Television Service Tips

Volume XXII
Issue 2
January 29, 1971

Prepared and Distributed by **RCA Sales Corporation, Product Performance**
600 N. Sherman Drive, Indianapolis, Indiana 46201

Power supply circuit—CTC 44

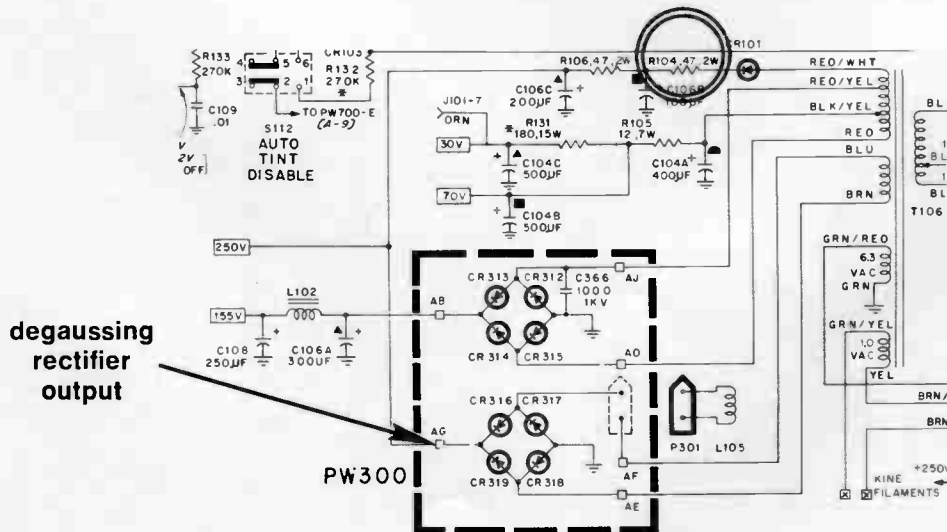
R104, in the 250V DC supply circuit, is a 47 ohm, 2 watt flame retardative (film) type resistor in early-production instruments. In the event this resistor fails, the instrument may continue to operate on the 220V DC supplied by the degaussing bridge rectifier output. See **Automatic Degaussing** on pages 49 and 50 of the **RCA 1971 Product Technical Manual** for a detailed circuit explanation.

Symptoms for R104 failure may include a hum bar and/or degaussing "interference" in the raster. For a quick check unplug the degaussing coils. Loss of video will result if the 250V DC supply is inoperative.

In those specific chassis where R104 fails, replace with a 47 ohm, 4 watt flame retardative type resistor (Stock No. 132879, Drawing No. 993118-241). Replacement information for R106 (47 ohm, 2w-film) is: Stock No. 132951, Drawing No. 1408729-393.

Kine bias, clamp circuitry—CTC 44

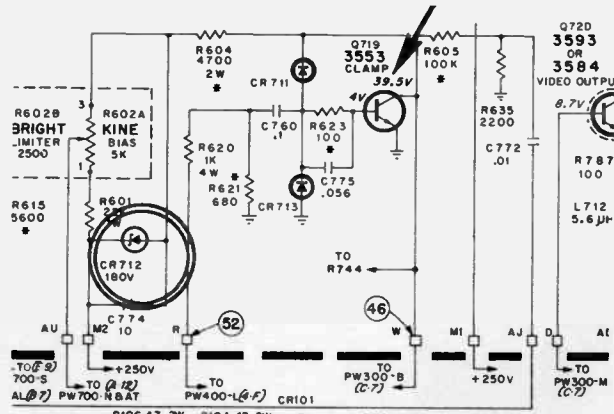
Also, in Service Data 1970 No. T15 (the CTC 44 chassis) on page 30 of the schematic diagram the collector voltage of Q719 clamp transistor should read "139.5V".

**schematic correction
normal reading 139.5V**

Circuit modifications—CTP 19A

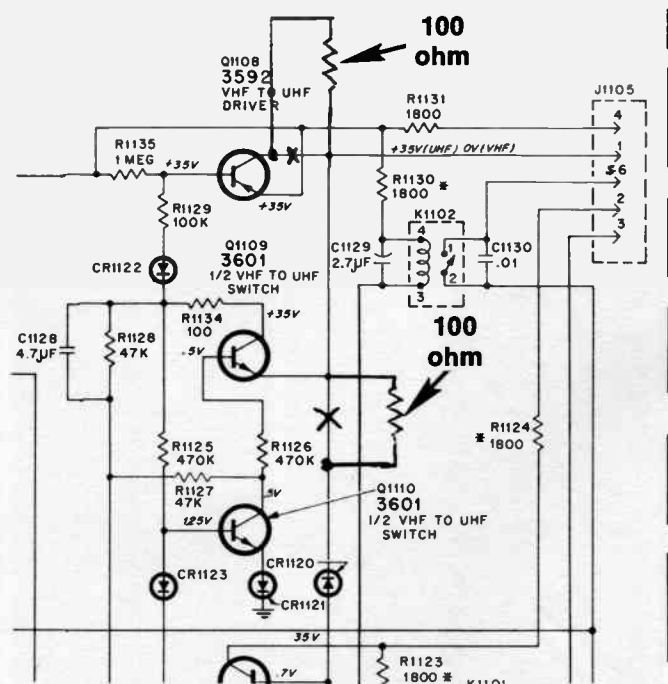
If the VHF to UHF Driver transistor (Q1108) in the CTP 19A remote amplifier fails (shorts) the instrument will go to the "U" function only.

Should this failure occur in early-production versions of this chassis the following circuit changes will improve reliability. Later-production chassis have these changes.

1. Add a 100 ohm, 1/2 W resistor (Stock No. 502110, Drawing No. 735730-50) in series with the collector lead when replacing Q1108.
2. Unsolder CR1120 cathode lead and add a 100 ohm, 1/2 W resistor (Stock No. 502110, Drawing No. 735730-50) in series.

Kine bias control circuit—CTC 39X

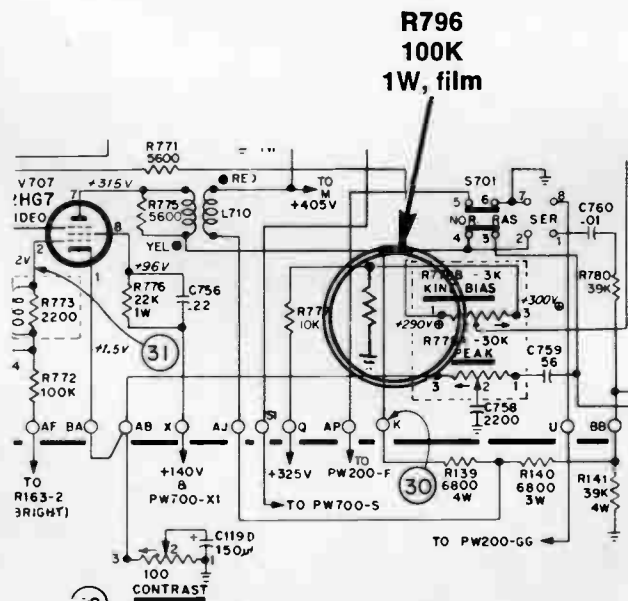
Reduced Accu-Tint range in the CTC 39 chassis may be the result of a resistor (R796, 100K, 1/2 watt) changing value. There also may be a tendency towards blooming during scenes which contain large areas of red information.

SYMBOL No.	STOCK No.	DRAWING No.	DESCRIPTION
R796	133057	993115-273	100K ohm, 1 watt, film

Screen Control Circuitry—CTC 39X

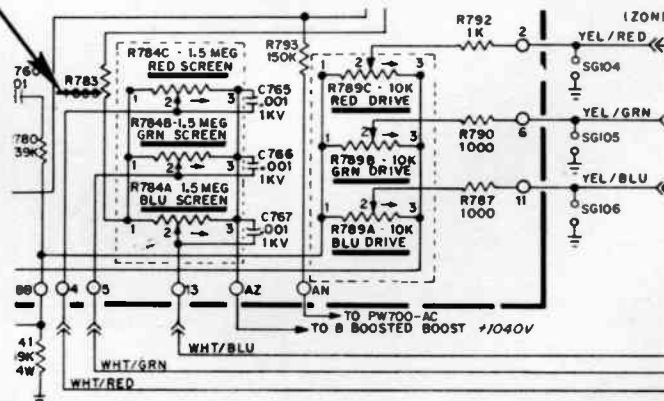
The resistance of R783 is shown on the schematic as "1000". The correct value is 100K. Using a 1000 ohm resistor in this application may result in color temperature setup problems and/or reduced Screen control (R784A,B,C) life.

Should Read "100K"

A. Commutator SCR 102 Protection B. Schematic Correction—CR 405 CTC 44

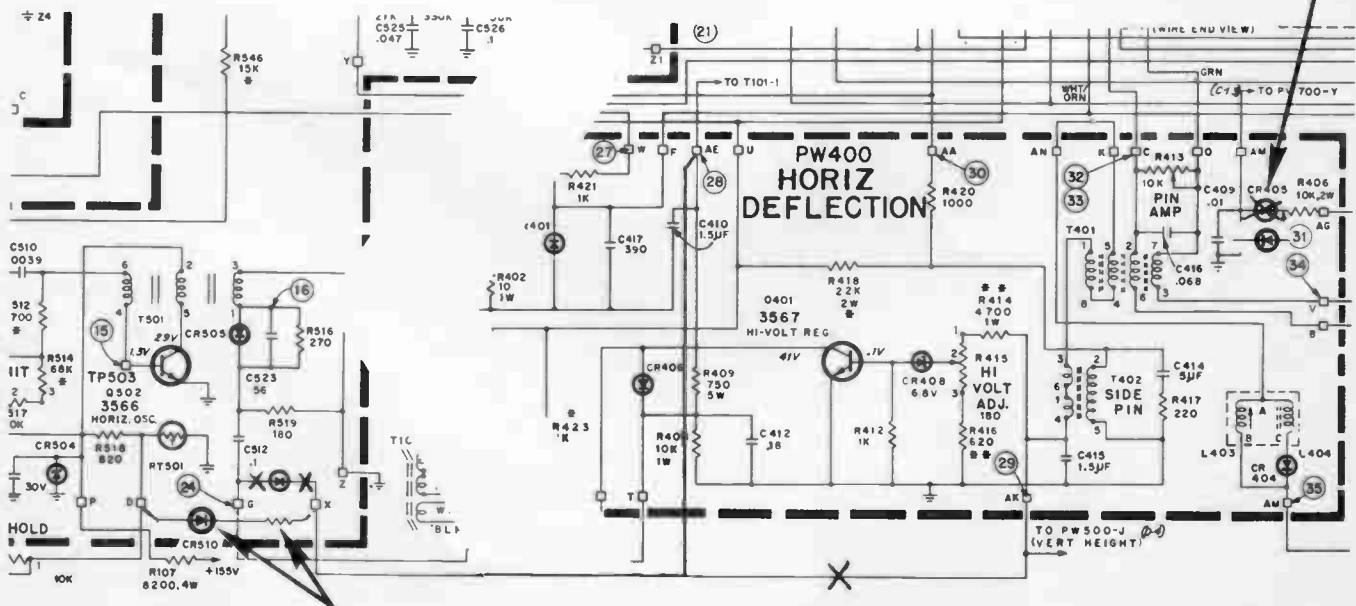
A. Should commutator SCR (SCR 102) failure occur in early-production versions of the CTC 44 chassis the following circuit change should be made to optimize reliability.

B. CR 405 is reversed on the schematic. The cathode rather than the anode should connect to terminal PW 400-AH.

1. Move CR 510 anode lead from PW 500-G to PW 500-D.
2. Add to 1000 ohm, 20%, 1/2 watt resistor in series with CR 510 cathode lead (to PW 500-X). Use heat shrinkable tubing or spaghetti over the diode and resistor.
3. Change the jumper connecting terminal PW 500-X to the PW 400 board from terminal AK to AE.

Figure 5—CTC 46 and CTC 54 Oscillator Disable Circuit Schematic Diagram

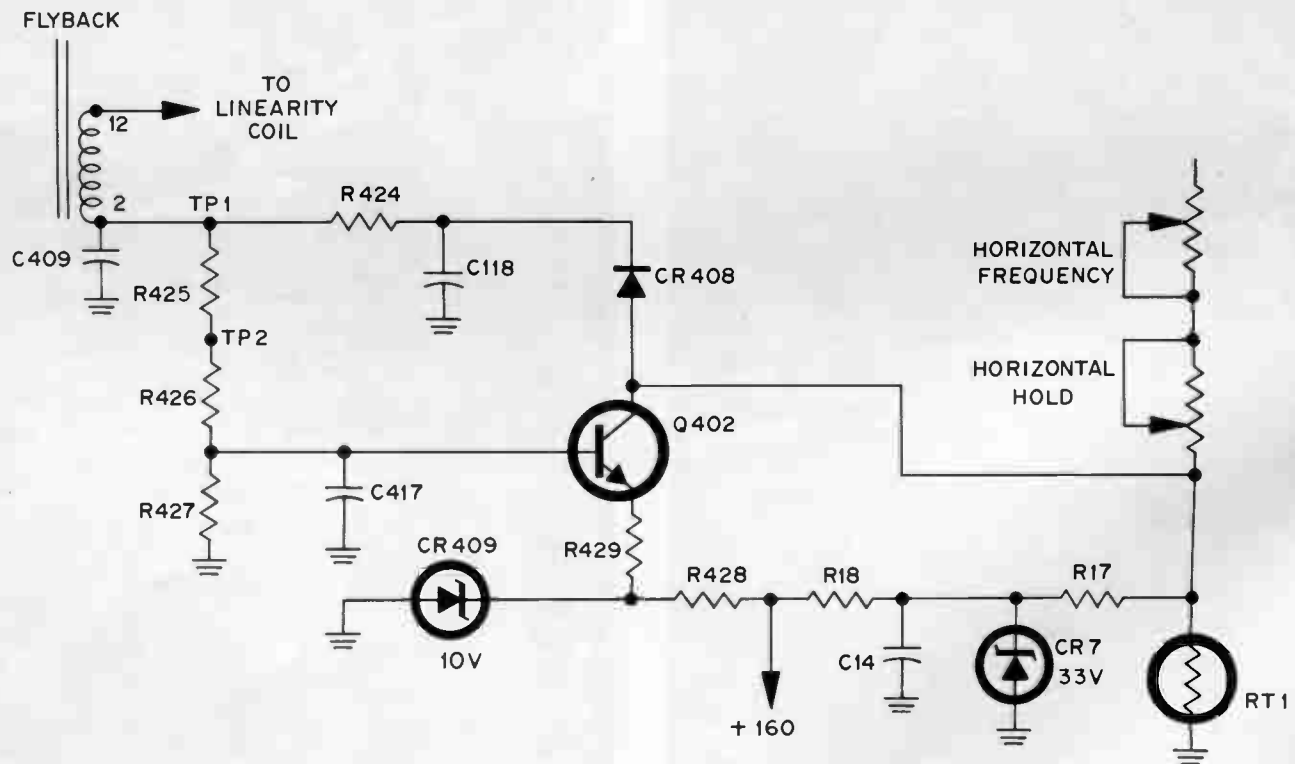
The CTC 46 and CTC 54 chassis employ the oscillator disable circuit shown in Figure-5. During normal circuit operation, transistor Q402 is non-conducting due to the emitter-base bias provided by zener diode CR 409 and voltage divider resistors R425, R426, and R427. The collector voltage (approximately +32 VDC) is applied to the bottom of **Horizontal-Hold** control during normal operation, supplied by zener diode CR 7 and associated components.

1. Replace resistor R429 (82 ohm, 1/2 W located in emitter circuit of Q402) with a **permanent jumper**.
2. Change resistor R122 (4700 ohm, 1/2 W, film) to a 1000 ohm, 2 W wirewound resistor (RCA Stock No. 132881). R122 is mounted on a terminal strip located on the rear of the chassis immediately behind the quadrupler.
